D70 MKII MODIFICATION INSTRUCTIONS

8/17/84

audio research corporation

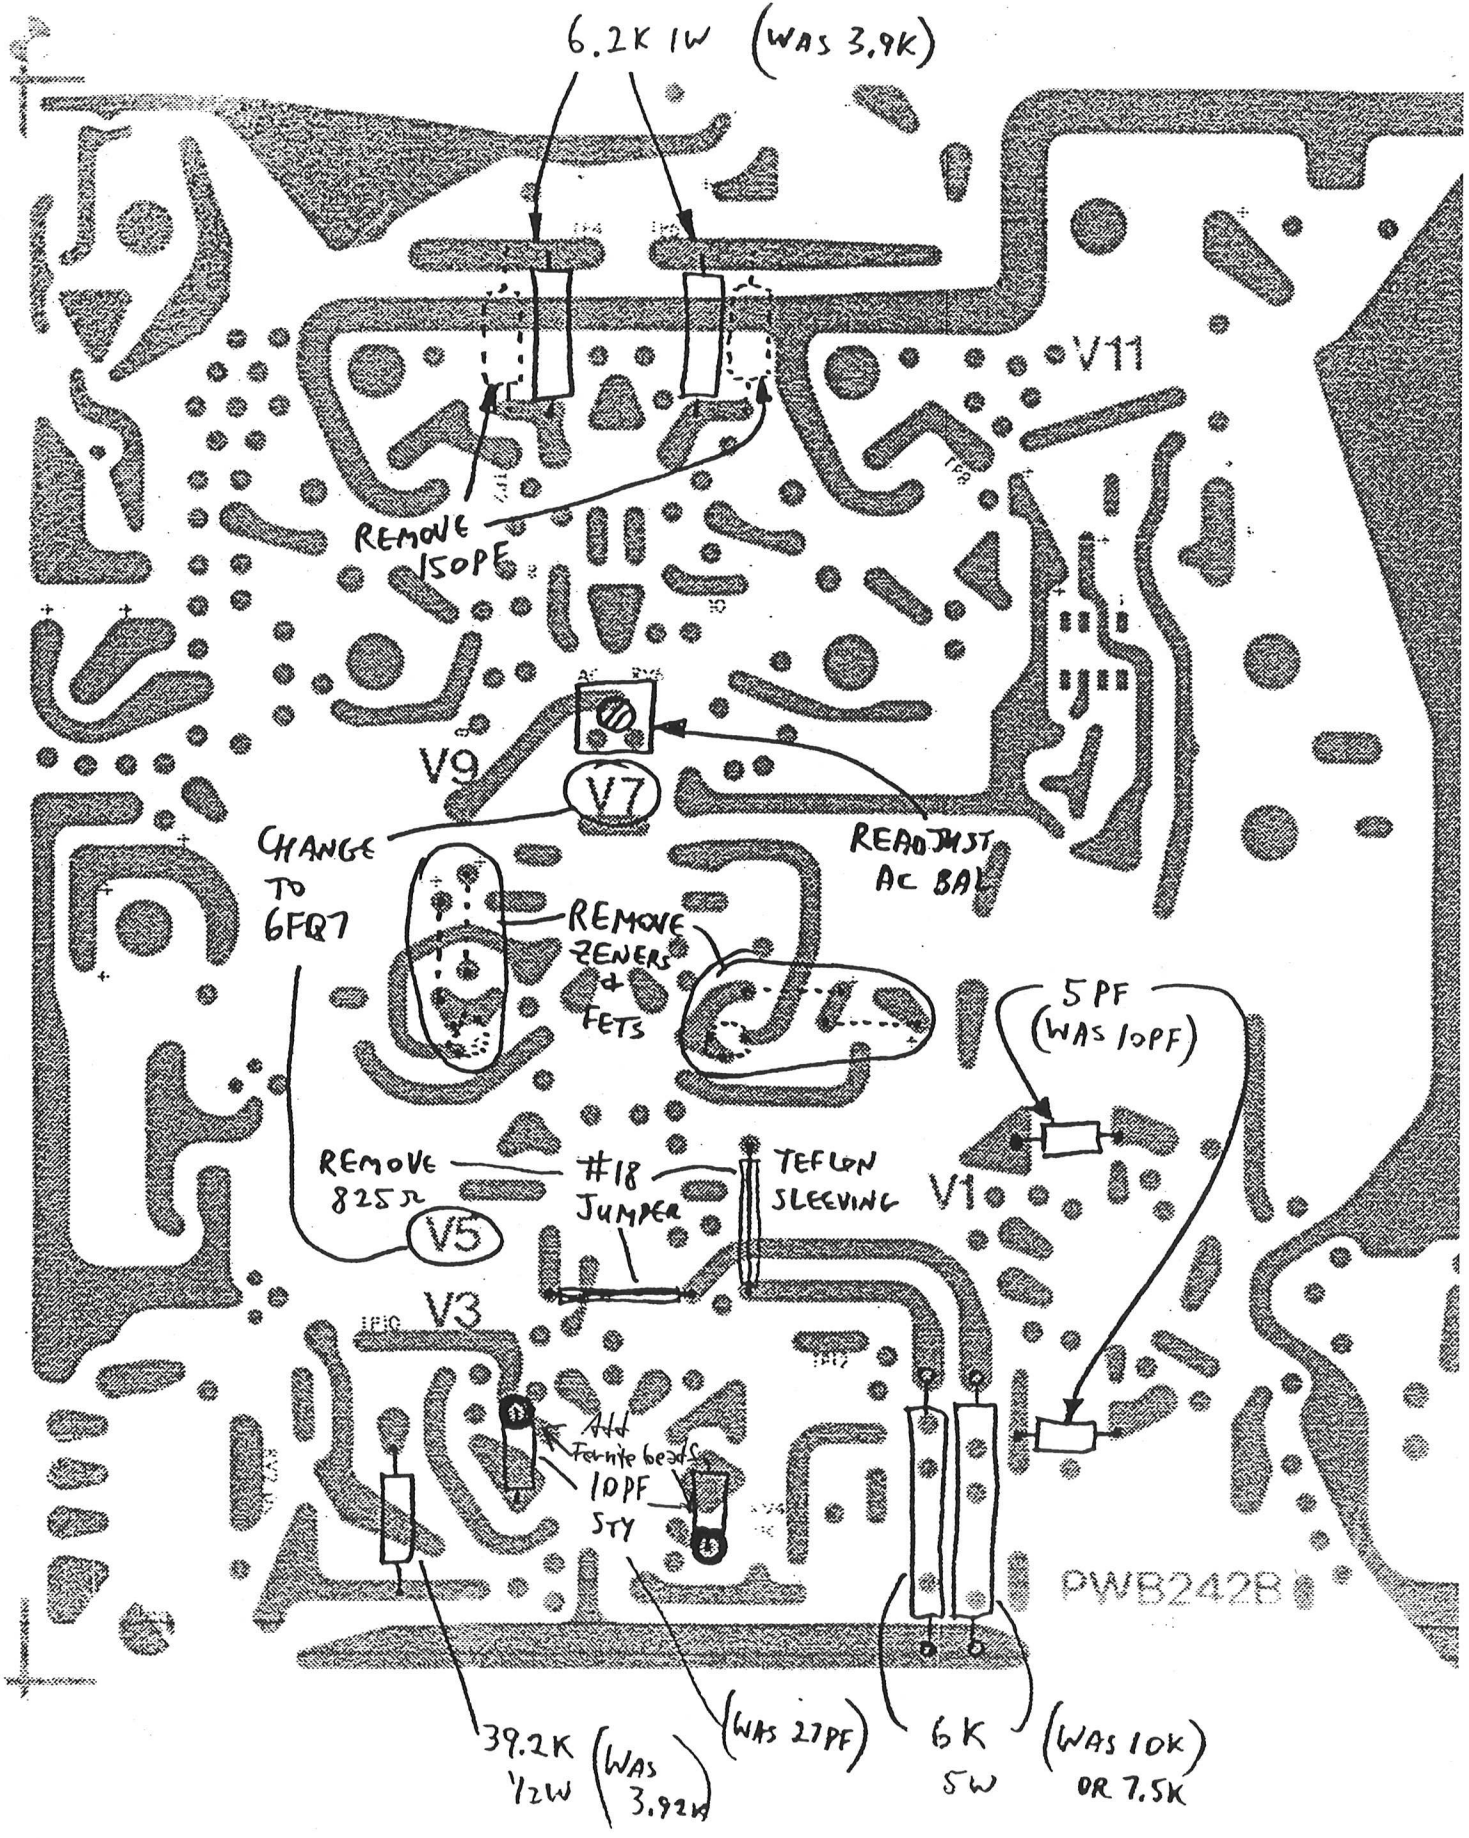
D70 MKII MODIFICATION PARTS LIST

PARTS ADDED:

- 4 - PN32000201 6FQ7 Vacuum tubes
- 2 - PN42392403 39.2K ohm MK3 Resista resistors
- 4 - PN43600300 6K ohm 5W 5% WW resistors
- 4 - ~~PN46620301~~ 6.2K ohm 1W 2% resistors *SUB 42619314 6.19K MK5*
- 2 - PN53500001 5pF Styrene 630V capacitors
- 4 - PN53100101 10pF Styrene 630V capacitors
- 1 - PN06190000 4" - #18 Audio wire
- 1 - PN06601710 2.5" - #18 Teflon sleeving
- 3 - PN00003700 Feet Audio Solder

PARTS DELETED:

- 4 - PN48825203 825 ohm 1% 1/2W resistors
- 2 - PN53100100 10pF Styrene capacitors
- 4 - PN53150200 150pF Styrene capacitors
- 4 - PN53270100 27pF Styrene capacitors
- 4 - PN30005900 2N5462 FET's
- 8 - PN30503800 1N5274B 130V Zener diodes
- 4 - PN32001100 6DJ8 Vacuum tubes
- 4 - PN48127302 1.27K ohm 1% 1/4W resistors
- 2 - PN48392303 3.92K ohm 1% 1/2W resistors
- 4 - PN43750300 7.5K ohm 5% 5W WW resistors
- 4 - PN46390301 3.9K ohm 2% 1W resistors
